Subject: Saxton Nuclear Experimental Corporation
Operating License No. DPR-4
Docket No. 50-146
Biennial 10 CFR 50.59 Report and Updated Safety Analysis Report

Attachment 1 – Biennial 10 CFR 50.59 Report
Attachment 2 – SNEC Facility Updated Safety Analysis Report (Rev. 3)

**SAXTON NUCLEAR EXPERIMENTAL CORPORATION FACILITY
UPDATED SAFETY ANALYSIS REPORT
BIENNIAL UPDATE**

Figure 1-1
SNEC FACILITY SITE LAYOUT

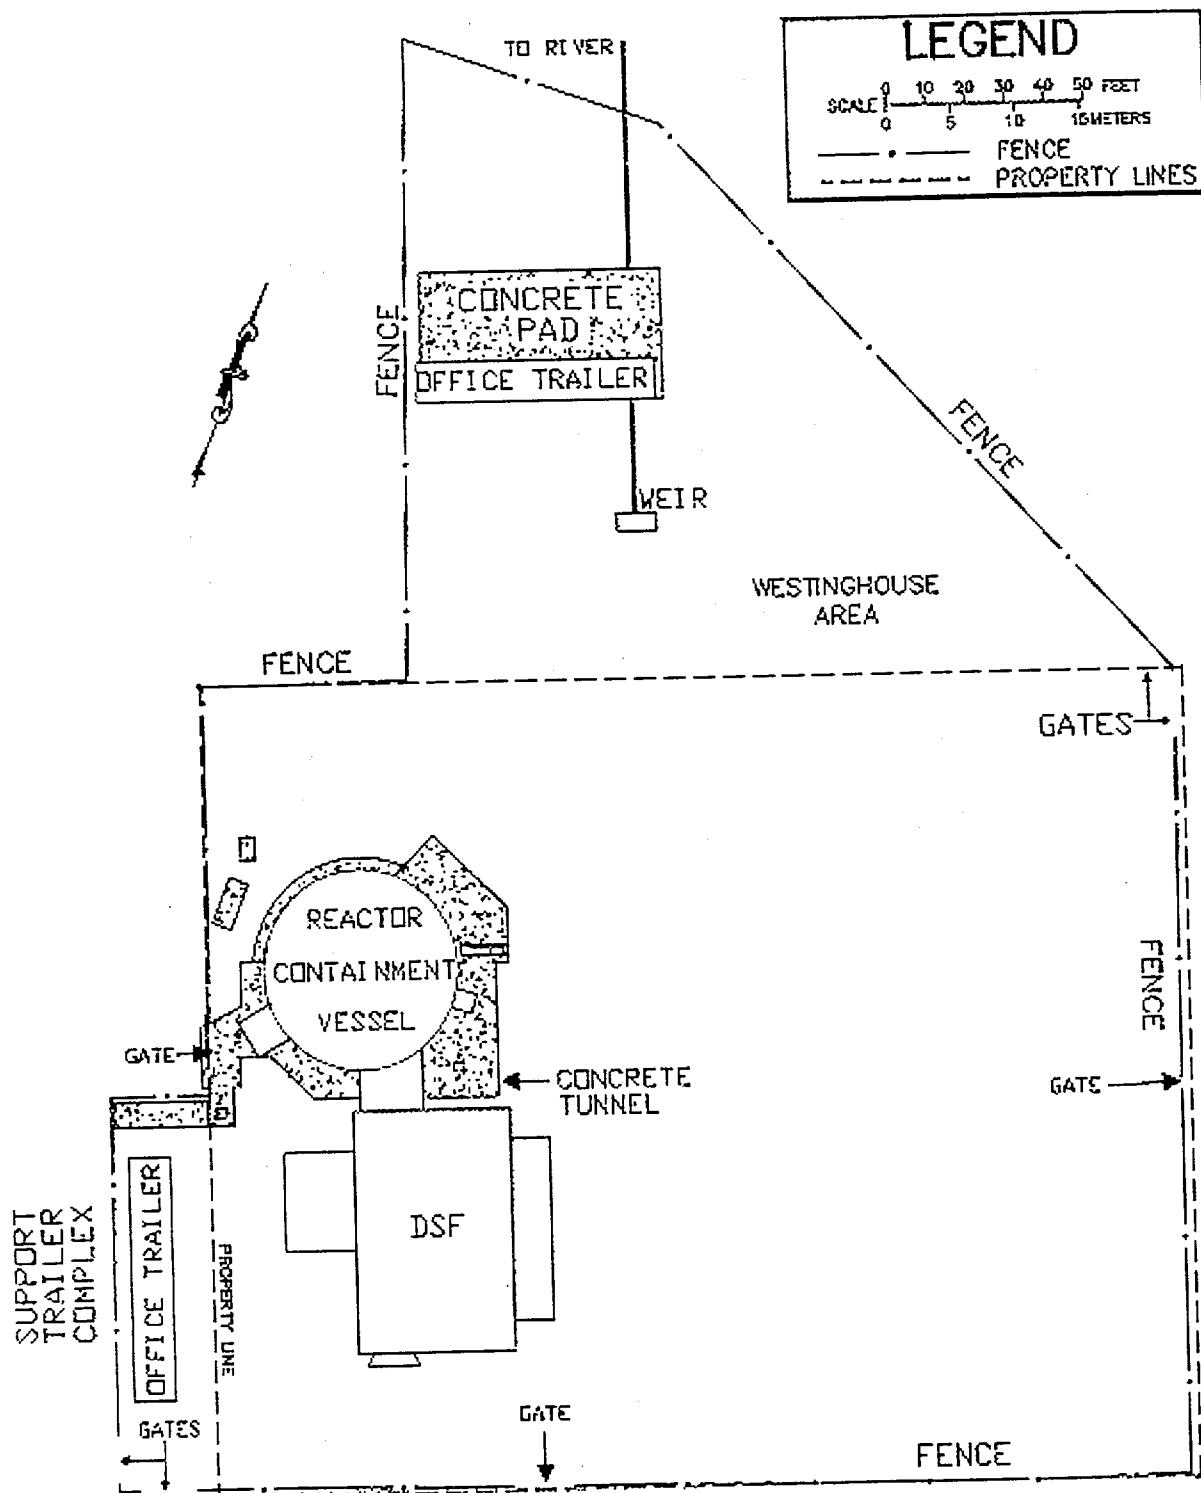
81. Figure 1-1, SNEC Facility Site Layout – has been updated.
82. Figure 1-3, Containment Vessel Sectional View – has been updated.
83. Figure 1-4, Containment Vessel Sectional View – has been updated.
